III. AMENDMENTS TO THE DRAWINGS

V. REMARKS

Fig. 4 *PRIOR ART*

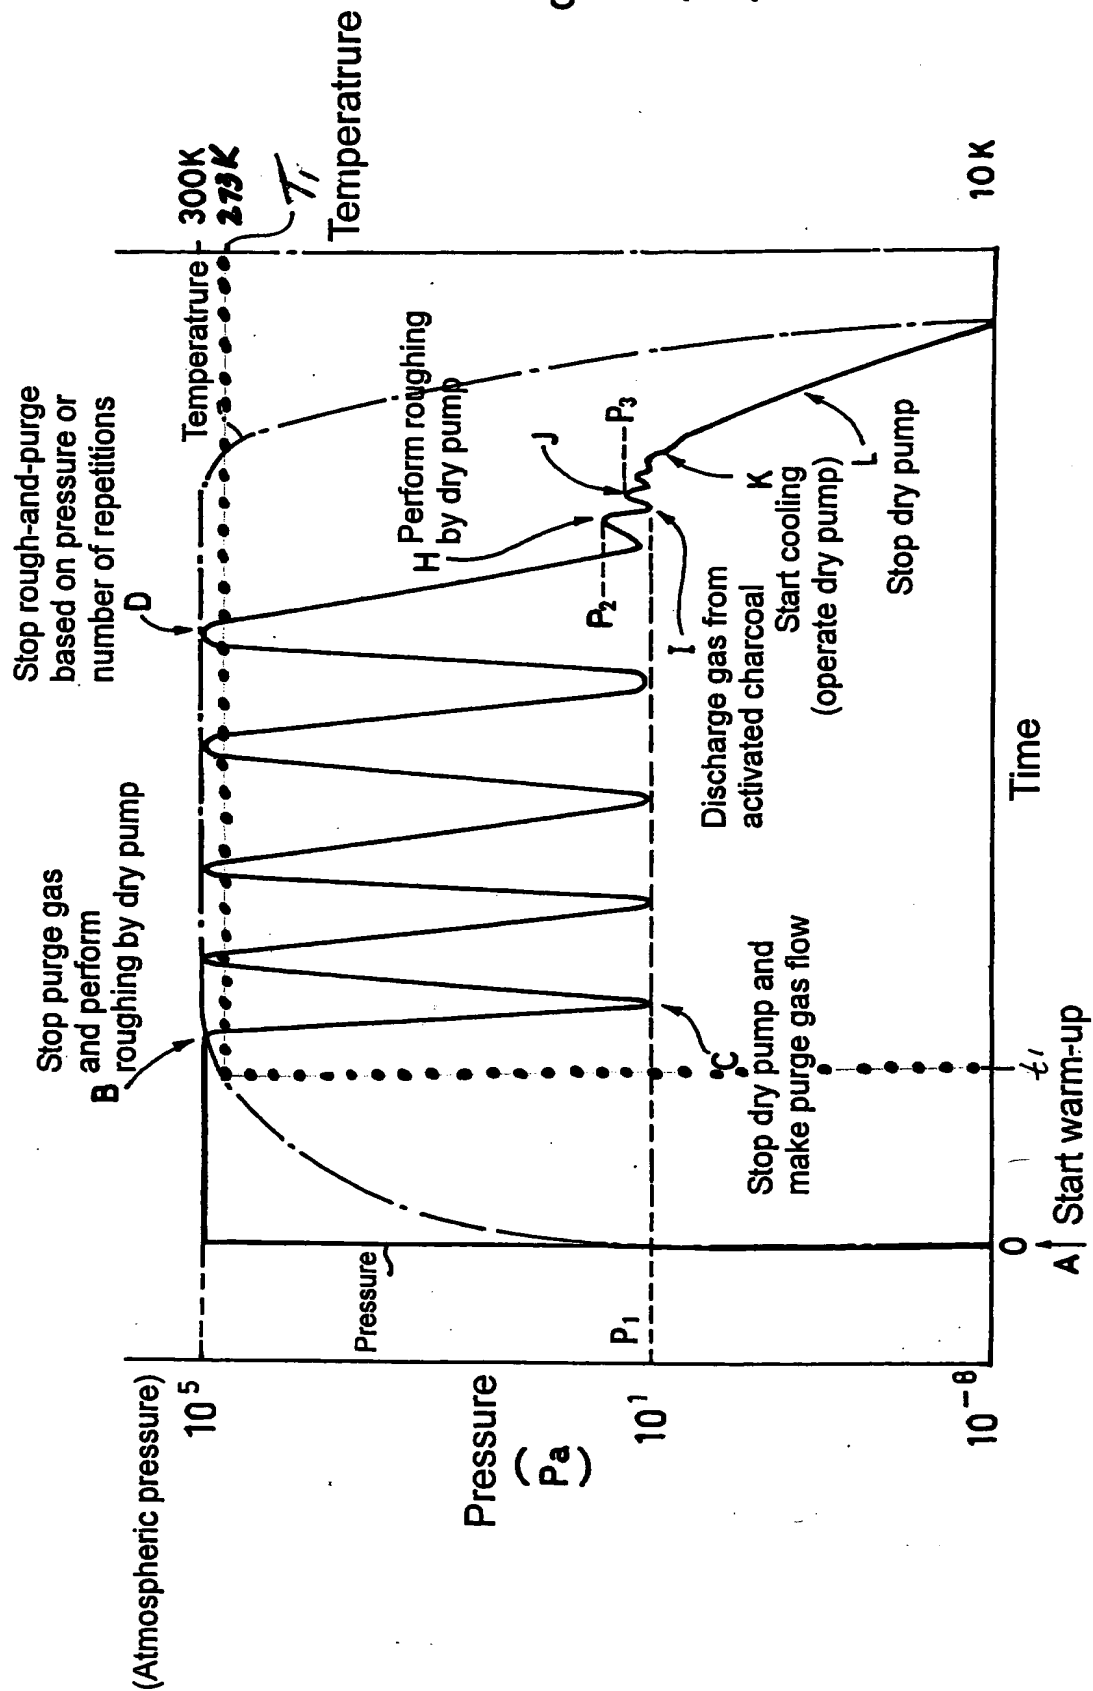
The Office Action recognizes the corrections to Figures 4 and 7. However, the Office Action finds these corrections to these figures are unacceptable because the dotted lines are

not labeled. The attached Replacement Sheets of Drawing Figures 4 and 7 now show the dotted lines being labeled.

Formal Replacement Drawing Figures 4 and 7 are filed herewith.
Replacement Drawing Figures 4 and 7 now show that the dotted lines are labeled.

t_1 - time when a temperature of the portion of the case in which the ice is condensed reaches the melting point of the ice

T_1 - temperature of the melting point of the ice, i.e., 273 K
